MAC-ENC-MTP-047

REHABILITATION STRATEGY

The Rehabilitation Strategy (the Strategy) is the standard for rehabilitation at Hunter Valley Energy Coal Pty Ltd (HVEC). The Strategy provides a framework for landform design and revegetation aligned with Regulator and community expectations.

Figure 7: Predicted view of landform from Denman Rd: A –landform at 2016, B – landform 5 years after completion, C - 10 to 15 years after completion.

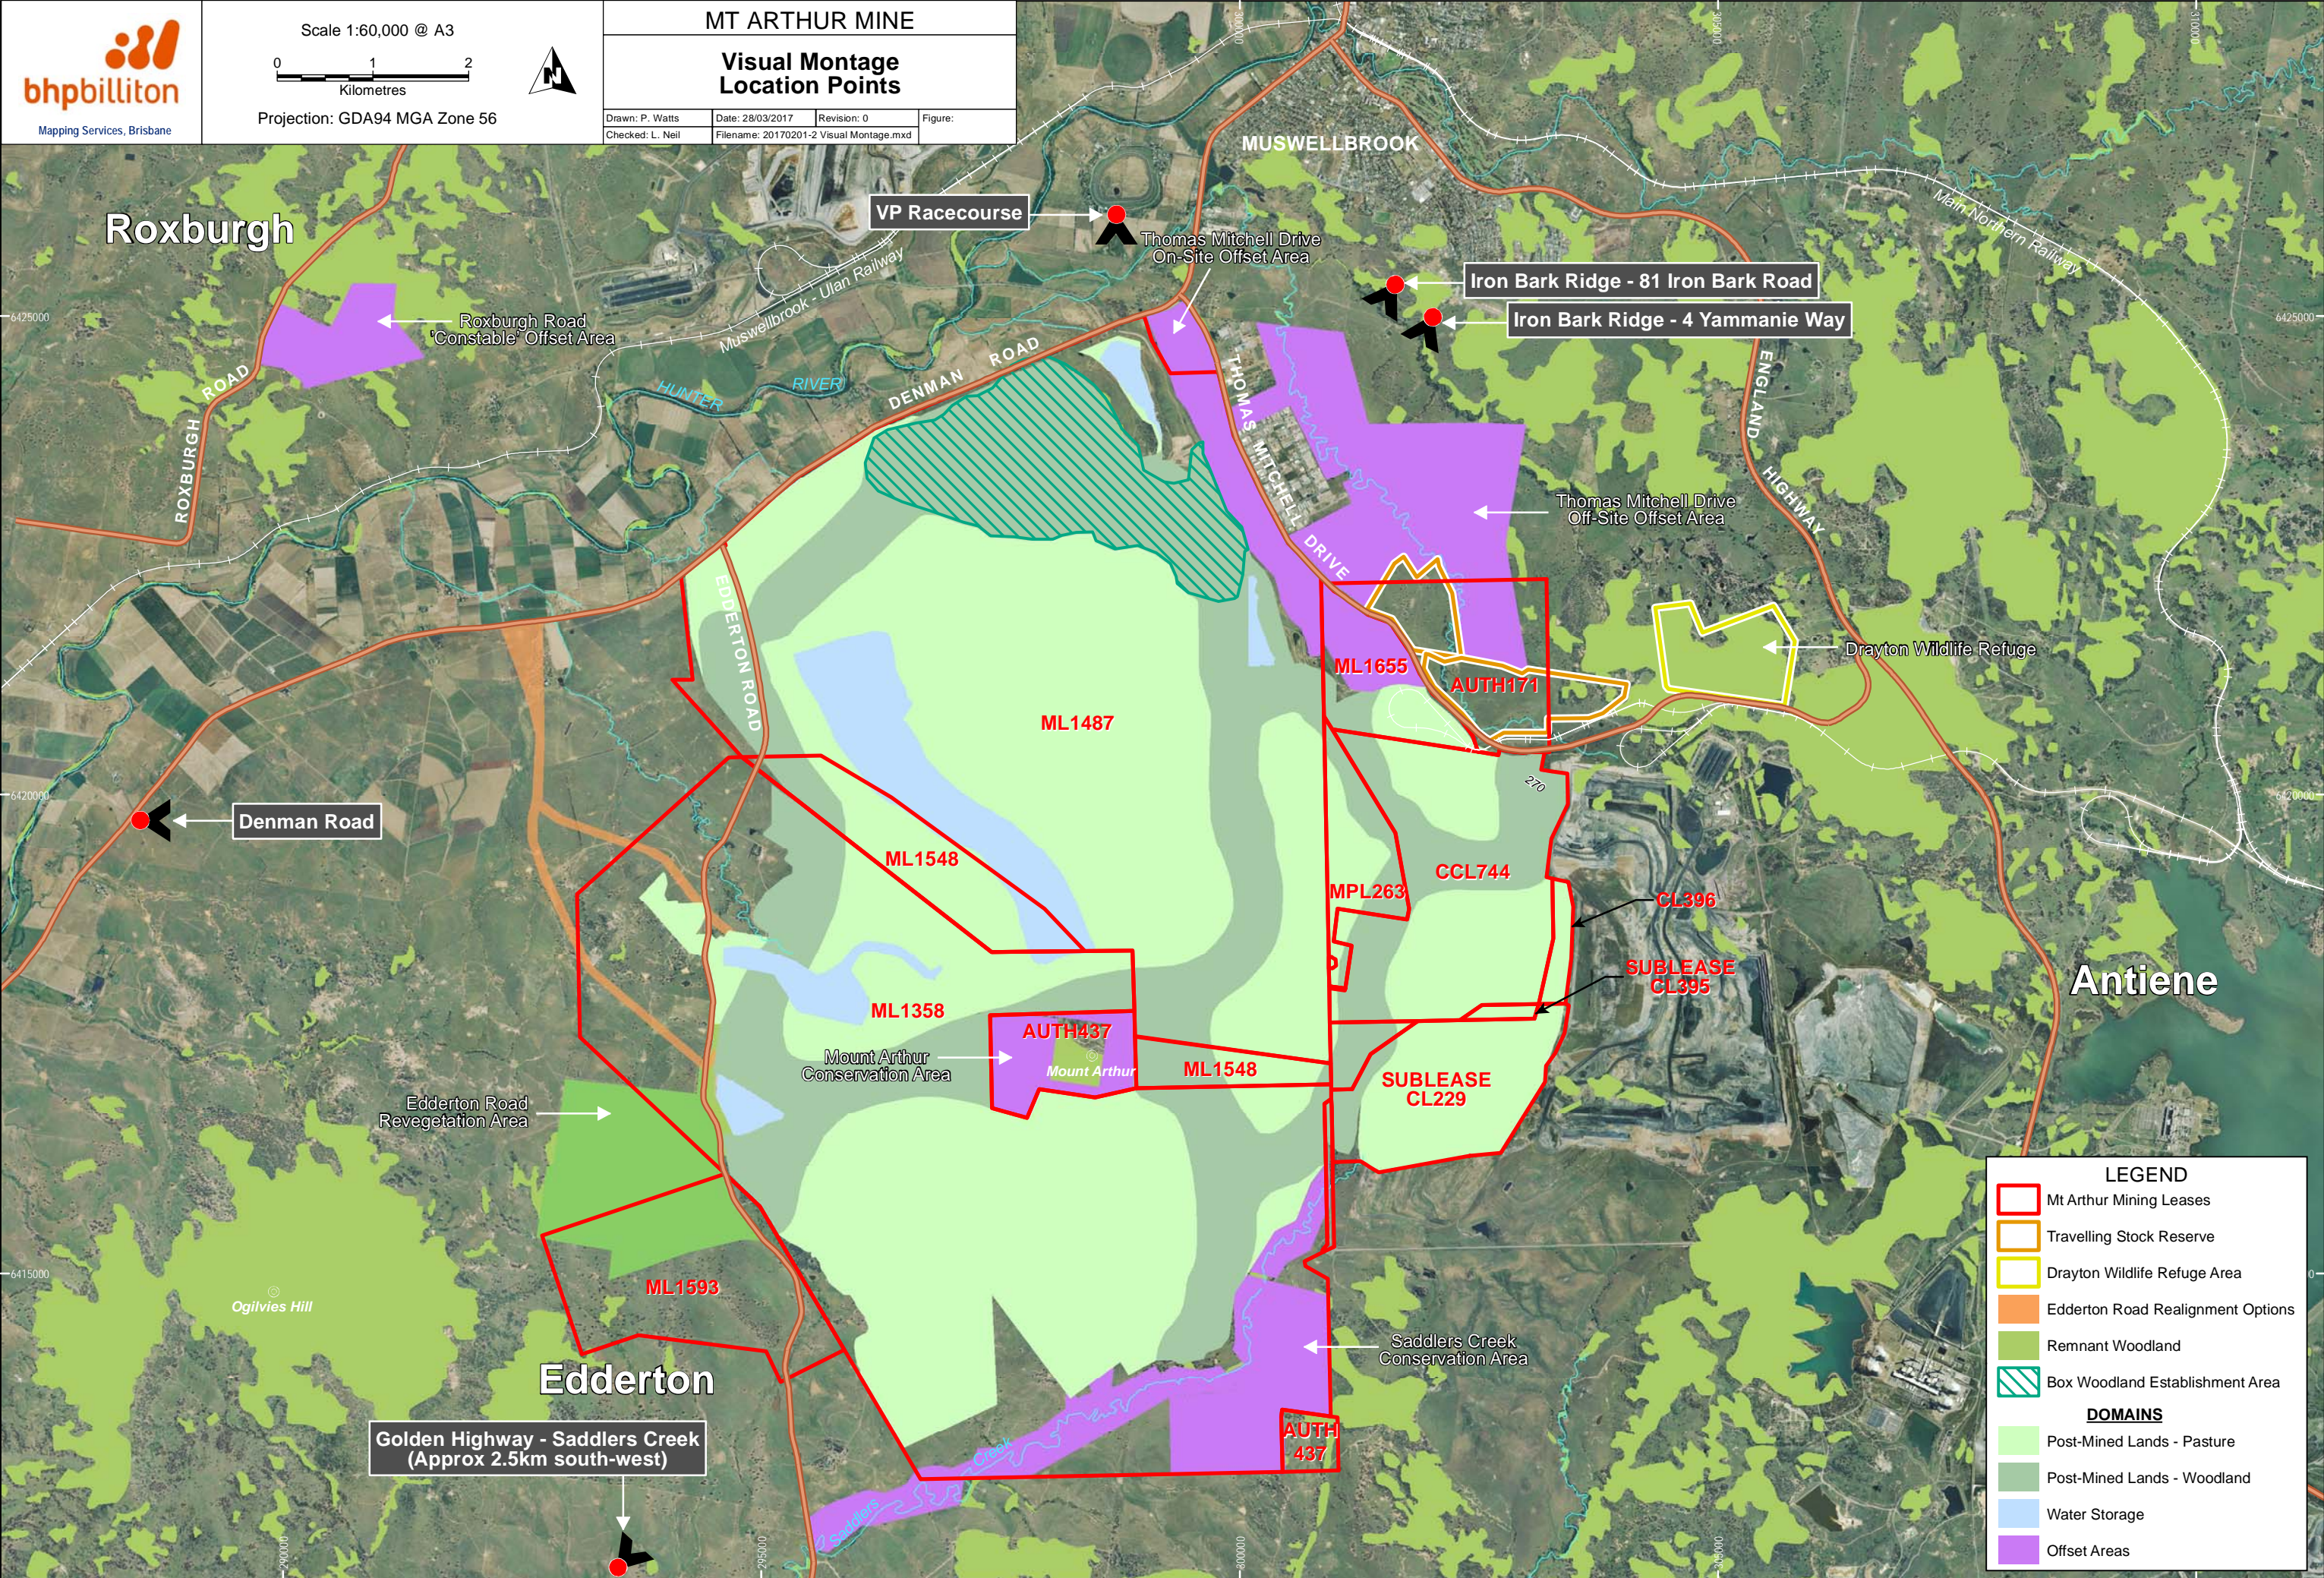
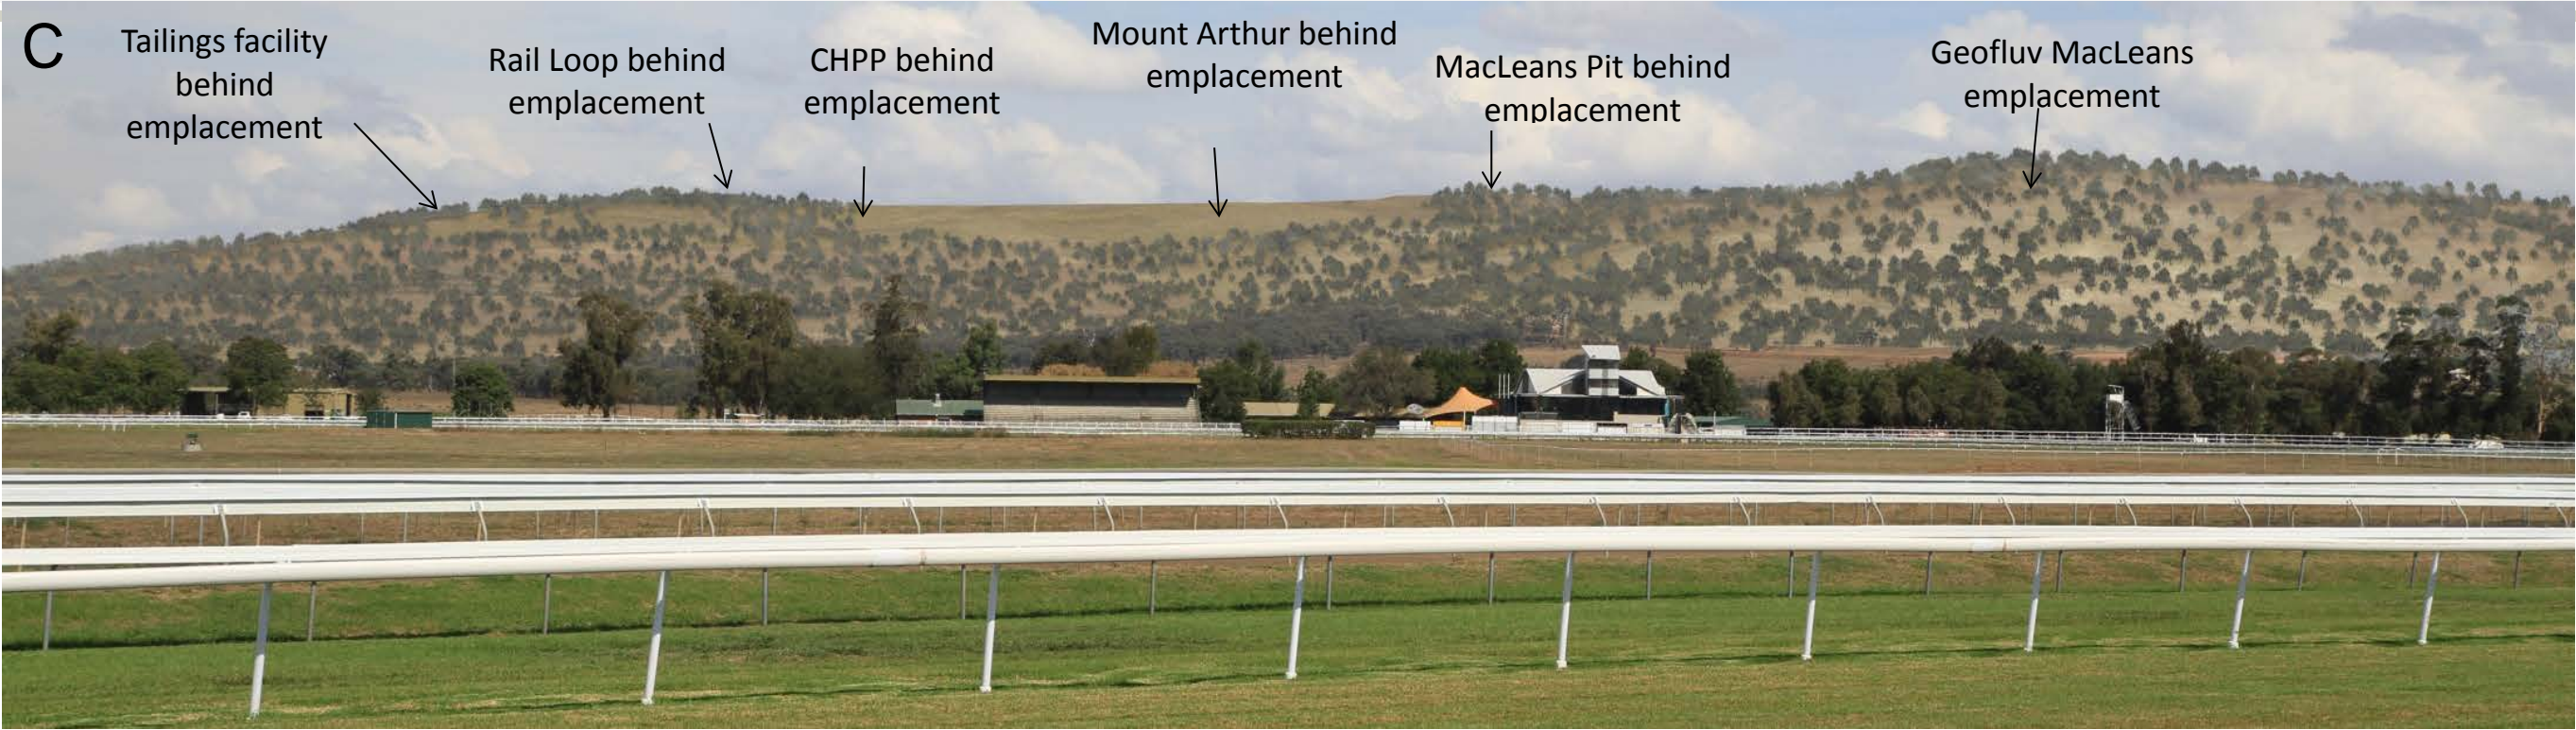
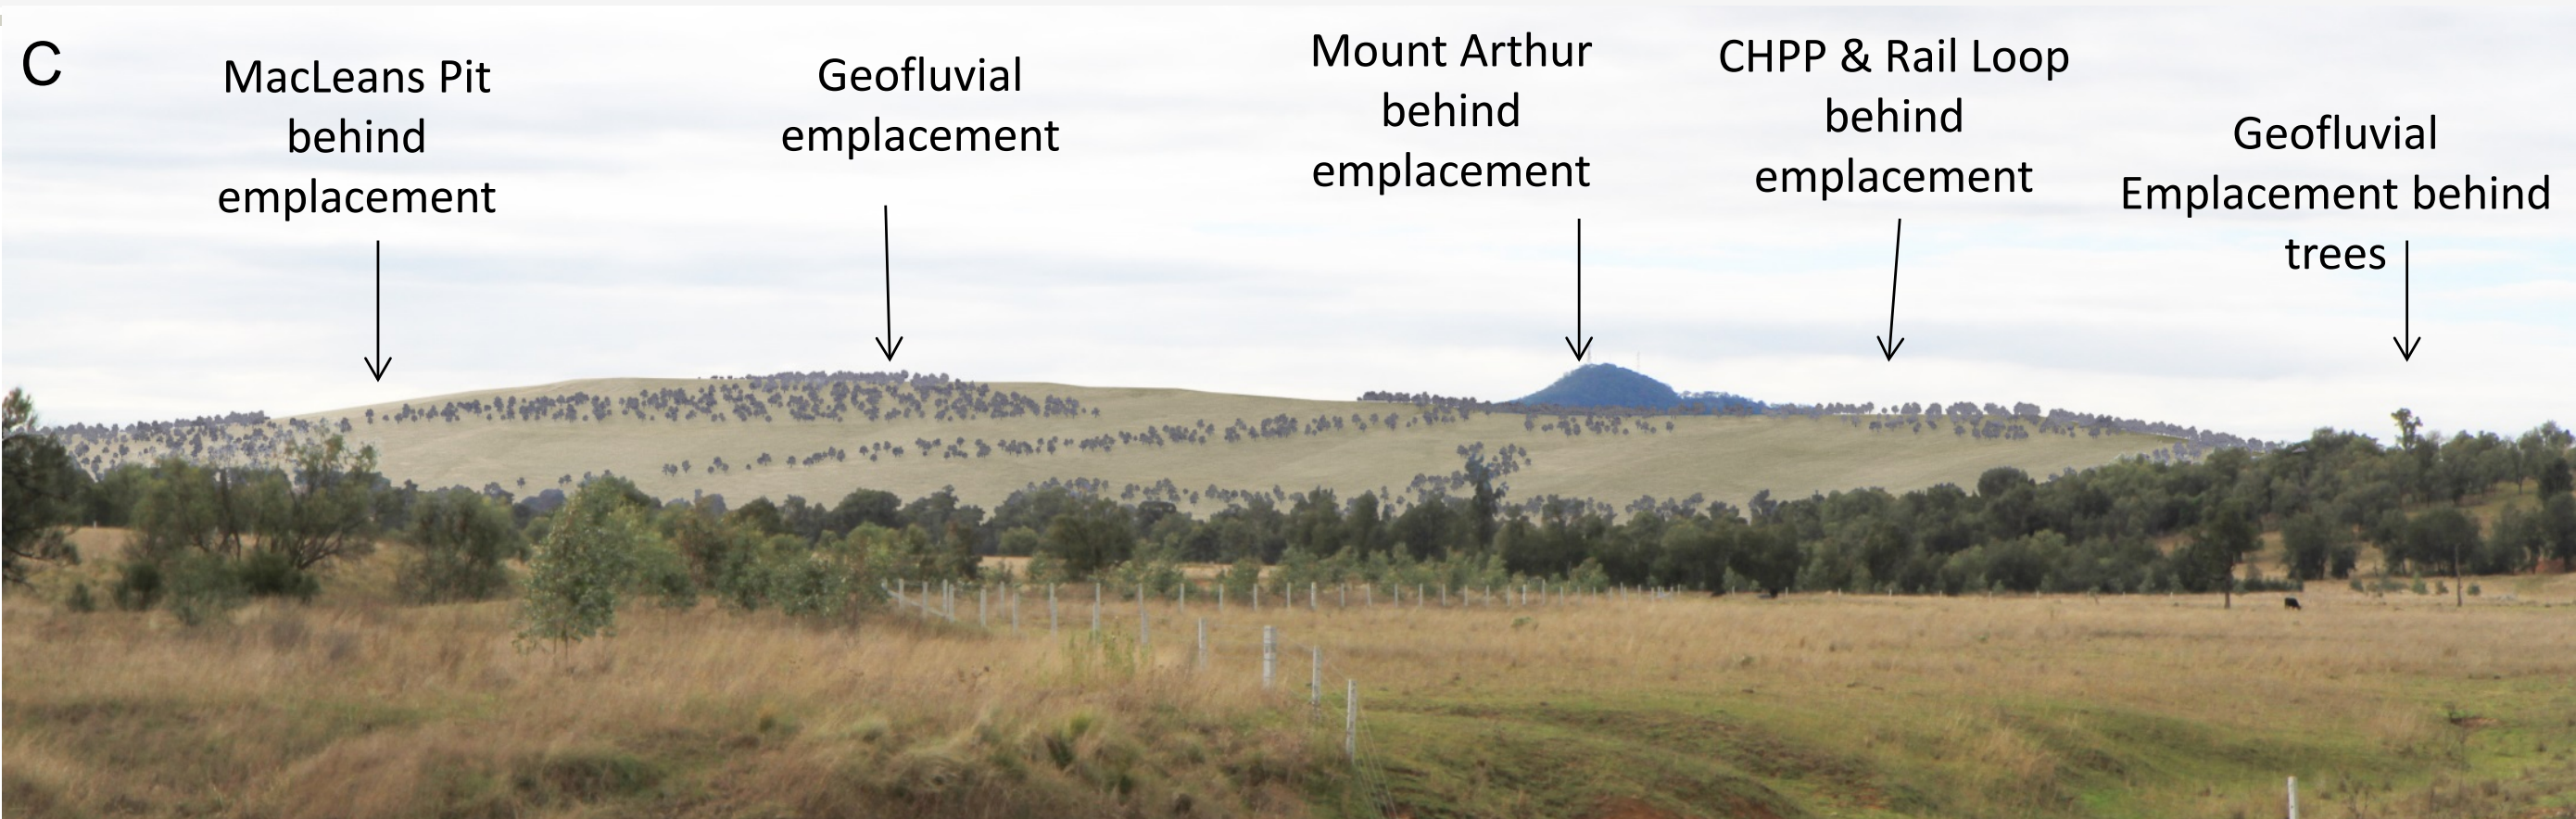
- *Table 14 in the development consent requires Mt Arthur Coal to integrate micro relief into the final landform design. Whilst the Strategy shows visual montages of how this may look at the completion of mining, further detail is required in relation to the following:*
 - *A polygon to show where these natural landform design principles will be implemented – further landform design details can be provided in the MOP*
 - *Justification for where these principles will not be adopted on site (e.g. existing*

- *Include visual montages that show key interim stages (eg. Upon landform completion, 5 years after completion, 10 -15 years after completion)*
- *Enhance visual montages by including labelling to highlight the natural landscape features integrated into the final landform.*
- *It is the expectation that detailed landform design will be presented in the MOP for submission to DRE. As discussed at the DRE / BHP Billiton meeting on 23 August 2016, MOP Plans should be developed separately for the different zones on site in order to provide better granularity in landform design.*

- Vegetation types, and pasture locations are shown in Figure 3b of the MOP and figure 3 of the new rehabilitation strategy.
 - Further staged montages will be included in the Strategy for MacLeans area. Labels on the montage will be improved for explanation
